# CERTIFICATE OF APPROPRIATENESS PLACARD

506 N BOUNDARY STREET

- Changes to previously approved COA 098-17-CA
- Install aluminum-clad wood window
- Move existing door and two windows
- Install rear deck/step

# Raleigh Historic Development Commission – Certificate of Appropriateness (COA) Application

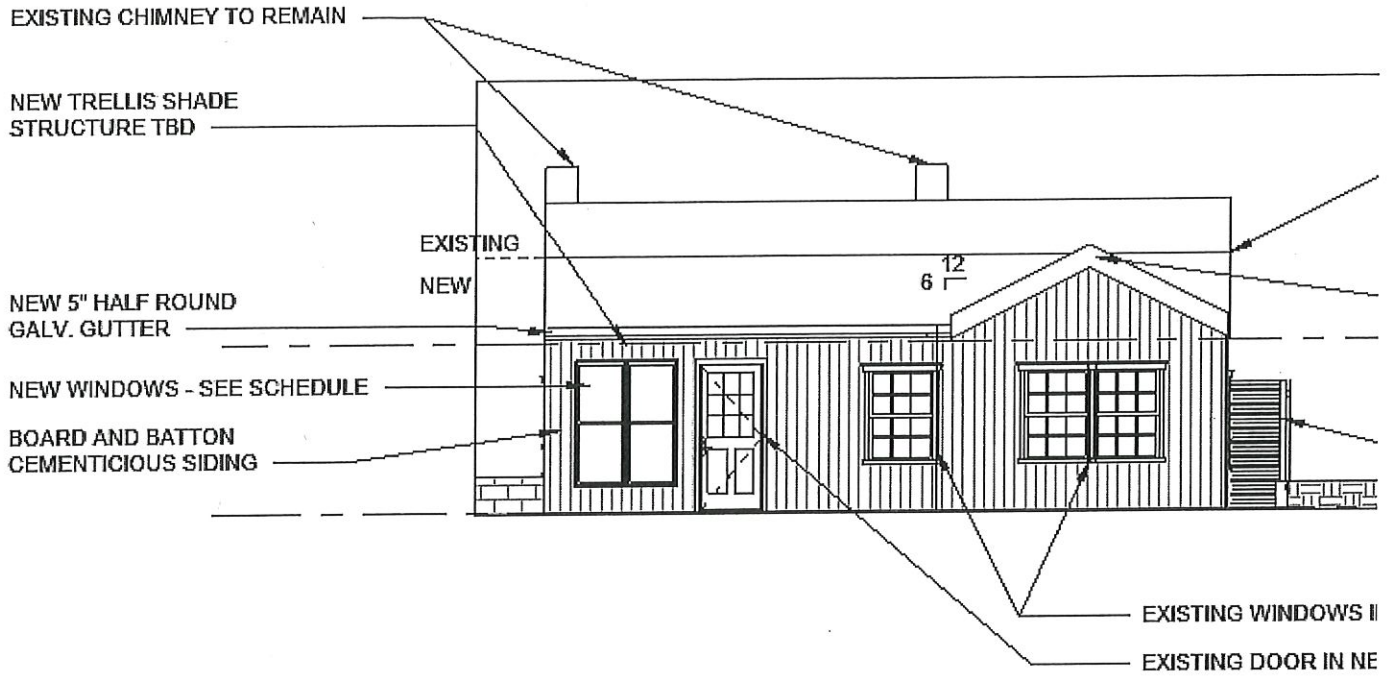
I'm reviewing your minor work COA application and have a couple of questions. The drawing that was circled and is labeled Alternate Deck shows you are using aluminum clad wood windows and a door on the back of the house, without the original bay window. The question is will you be doing the deck shown in the drawing at this time? If so, we'll need to see some more details on the components of that including the deck design and materials, the concrete bench and concrete pavers, the new retaining wall, and the 4x4 steel columns with wood trellis above with a polycarbonate rain shield above the door. We would need to see a more detailed plan drawing of the outdoor area itself as well as an elevation drawing or two that shows how it will all look when completed.

1. The trellis, bench, and columns are not included in this part of the project - we may ask about these once we get the permit and if there is money in the budget to include them... The pavers are also not included, but have been shown in the early COA. These are salvaged and there are photos.
2. The deck is more a generous step, than a deck, but we feel the RHDC will see it as a deck so we've included a detail. We are not building new retaining walls, but will cut a section out of the existing wall and grade to install the new step at grade with the kitchen floor. This is a wide step and will be pressure treated 1x4 that will be semi opaque stained once they are dried out. It is about 6" Above grade.

## ALTERNATE DECK

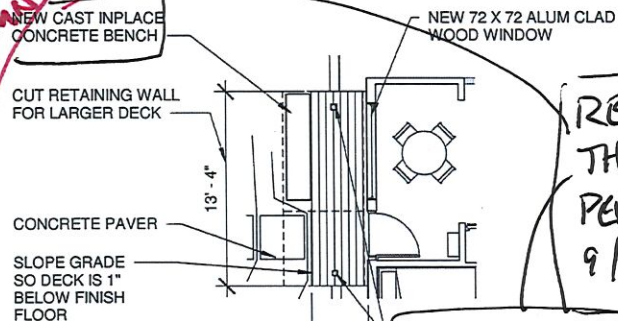
*no bay window*

*instead we are doing this*

*using existing door instead*

NEW 4 X 4 STEEL COLUMN PAINT  
NEW 3'0" X 7'2" GLASS FULL LITE ALUM CLAD WD DOOR

4X4 TUBE STEEL COLUMNS W WOOD TRELLIS ABOVE. POLYCARBONITE RAIN SHEILD ABOVE DOOR

**REMOVED FROM THIS COA APPLICATION PER APPLICANT 9/20/17 MNR**

REAR ELEVATION + ALTERNATE

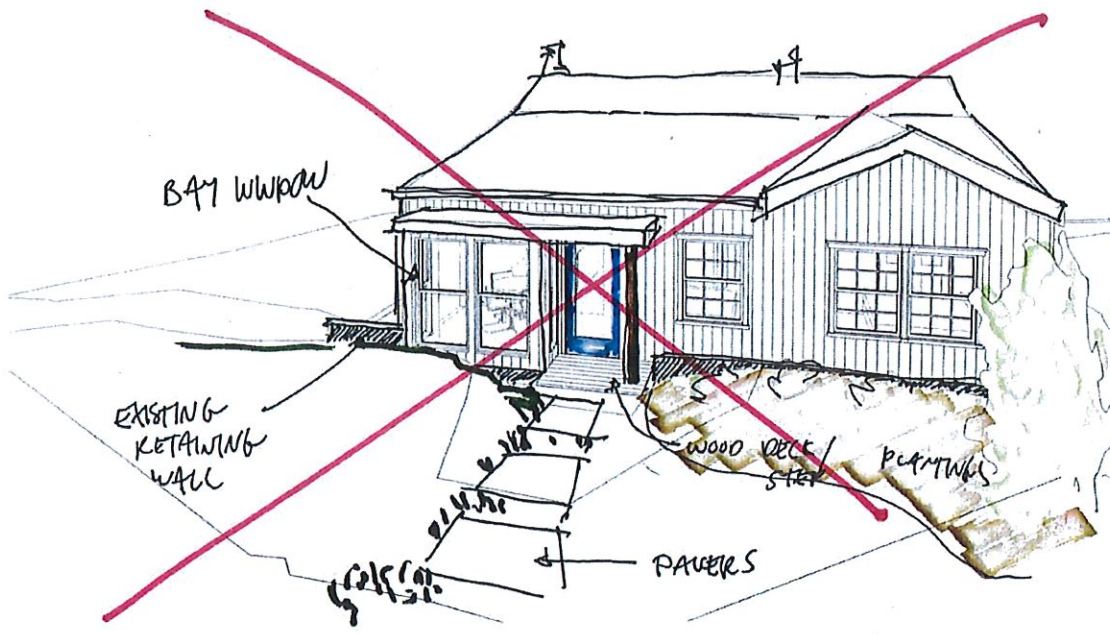
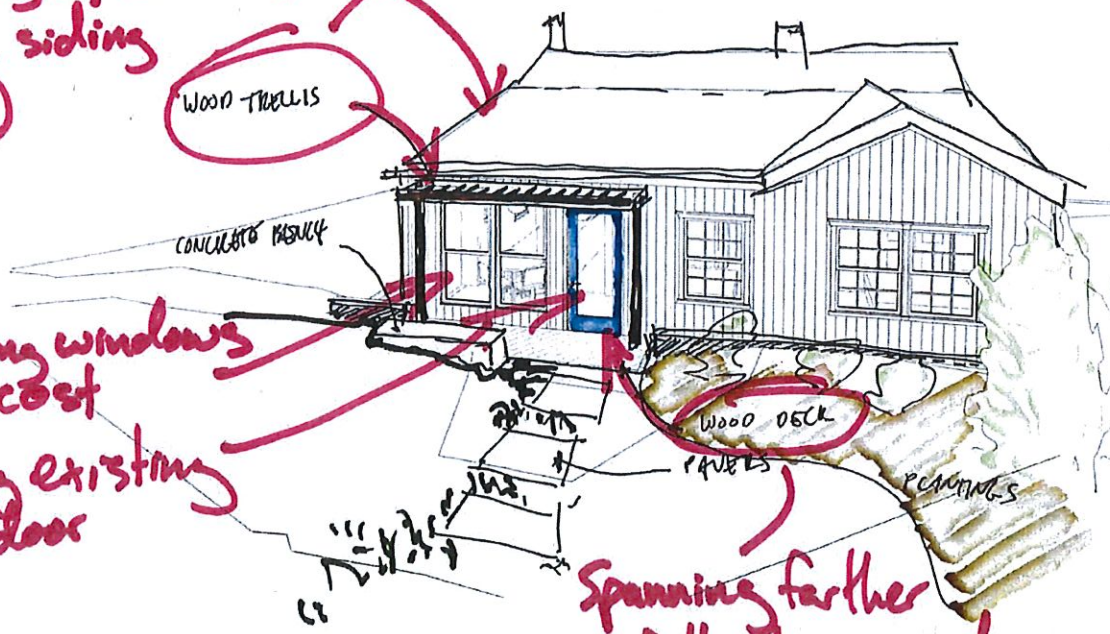
OPTION A

Removing existing window and filling w/ existing salvaged siding (see photo)

instead of membrane roof + bay window

Double hung windows to save cost  
reusing existing back door

Spanning farther to fill where window would have been

OPTION B
